WRITTEN RESPONSE TO EDF CONSULTATION ON FURTHER PROJECT CHANGES - JULY 2021

DEVELOPMENT CONSENT ORDER EN010012 : THE SIZEWELL C PROJECT

PROPOSED CHANGE 16: i and ii - BRIDLEWAY 19 LEISTON cum SIZEWELL

Figures 1 and 1A: AS 013: Rights Of Way Plans – Sheet 5 of 27

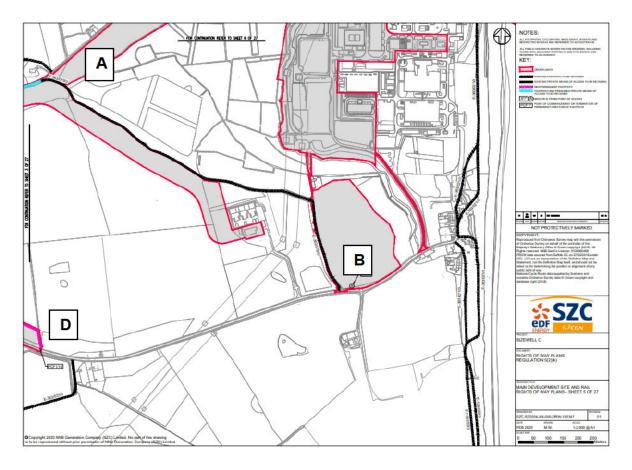
ii) With reference to AS 013: Rights Of Way Plans – Sheet 5 of 27 the southern section of BR19 known as Sandy Lane (shown from A to B on Figure 1: Right of Way Plan 5 of 27 below) is described in the Key (see Figure 1A) as 'existing footpath to be retained'. This section of BRI9 connects via an unclassified road to Byway 26 Aldringham cum Thorpe and beyond, as well as being the through route to the beach for equestrians using BR19. See Figure 2: Extract of the Definitive Map for Leiston cum Sizewell. Use of the beach by equestrians was identified in APP 270 page 65 paragraph 1.3.81

Proposed Change 16 Section ii incorrectly describes BR19 as

It would appear from **Change 16 Section ii** of the current consultation that there is a hidden intention to divert the southern section of **BR19**.

Although parts of the southern route of **BR19** are situated within the development boundary, the route is not affected by the proposed development so there is no need to consider a diversion of this public right of way as part of **Schedule 17 of the Development Consent Order** (DCO).

(AS 266) 8.5 Transport Assessment Addendum Section 12 paragraph 12.2.5 (page 150) assumes that the southern end of BR19 will remain open to the public during the construction phase. This is contradicted by Change 16 Section ii of the Consultation On Further Project Changes - July 2021.

Figure 2: Extract of the Definitive Map for Leiston cum Sizewell.

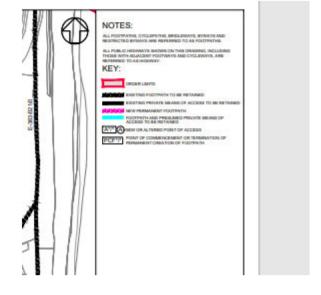
The route described in **Change 16 Section ii** is part of a proposed additional provision of off road bridleway (See Figure 2 marked C to D) as requested by local riders as a link to Bridleways 27 and 26 Leiston cum Sizewell. This addition to the local bridleway network is to be welcomed, but <u>is not</u> part of the definitive alignment of **BR19** and should not be created at the expense of the existing route of **BR19** (See Figure 2 marked A to B).
